Change to the appearance of deflecting pulley 532 0138 10

Item no.: 532 0138 10

INA 0030

Figure 1: 532 0138 10 - previous design

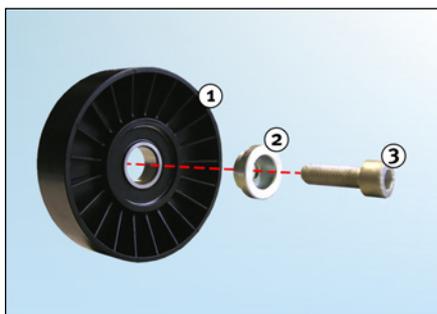
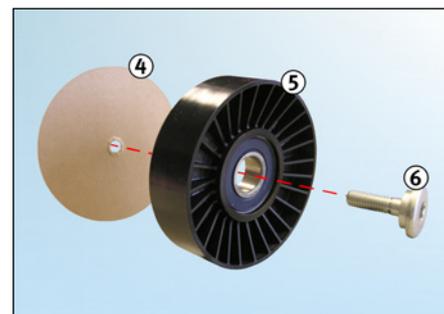
As part of our continuous efforts to improve our products, changes have been made to the deflecting pulley, item no. 532 0138 10.

1. Previous deflecting pulley design
2. Spacer
3. Screw

4. Cardboard disk (screw locking device – must be removed before assembly)
5. New deflecting pulley design
6. Screw (integrated spacer)
